**STAFF RECOMMENDATION**  
**1921 19<sup>th</sup> Avenue South**  
**June 21, 2017**

**Application:** New construction-outbuilding to DADU conversion  
**District:** Belmont-Hillsboro Neighborhood Conservation Zoning Overlay  
**Council District:** 18  
**Map and Parcel Number:** 10412017200  
**Applicant:** Caryll Alpert  
**Project Lead:** Melissa Baldock, melissa.baldock@nashville.gov

<p><b>Description of Project:</b> Application is convert a previously approved outbuilding, which is largely constructed, into a DADU.</p> <p><b>Recommendation Summary:</b> Staff recommends the Commission confirm the fact that the outbuilding meets the design requirements of a DADU. Staff finds the structure meets Section II.B.i. of the Belmont-Hillsboro Neighborhood Conservation Zoning Overlay design guidelines and the DADU section of the Ordinance, 17.16.030. G.</p> <p><i>It is currently the Commission's policy that all DADUs in historic overlays come to the Commission for review so that there is neighborhood notice. Approval does not approve use. Since there are no physical changes necessary for the new use or otherwise proposed, a permit will not be issued.</i></p>	<p><b>Attachments</b> <b>A:

### SITE PLAN

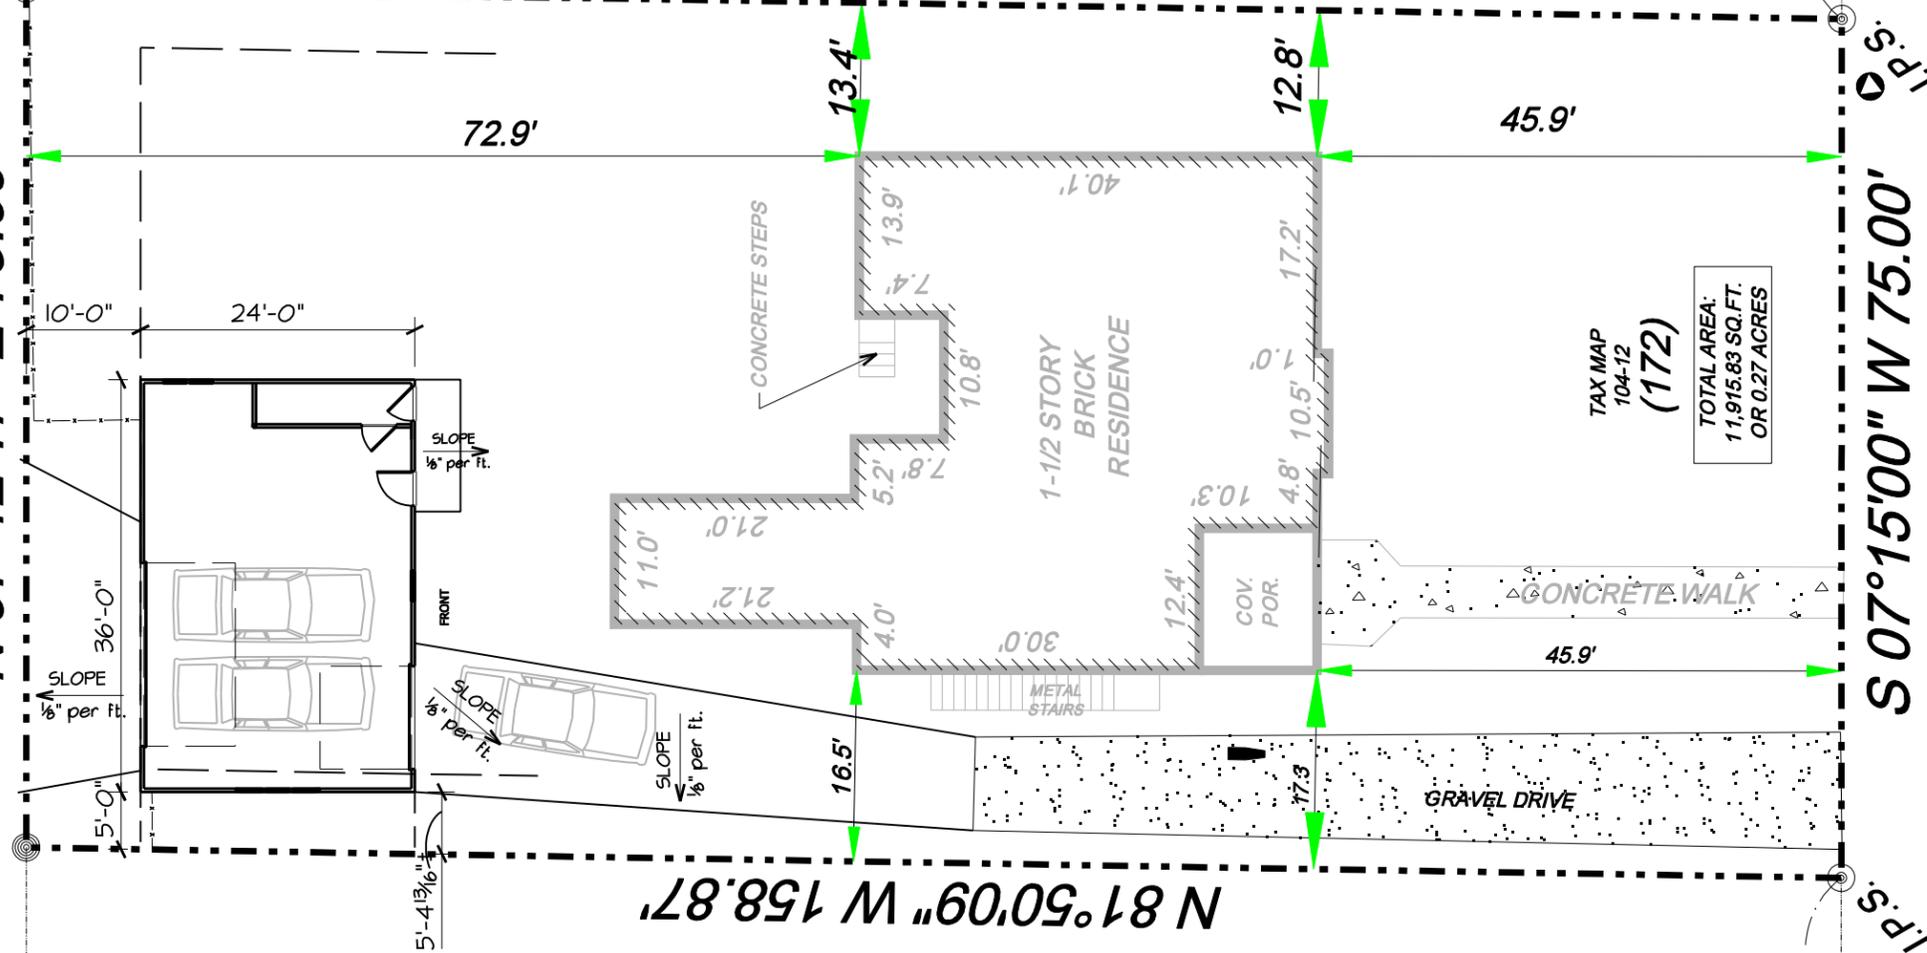
Revised 11/30/15 - Side setback increased to 5'

NOT TO BE USED AS A DADU
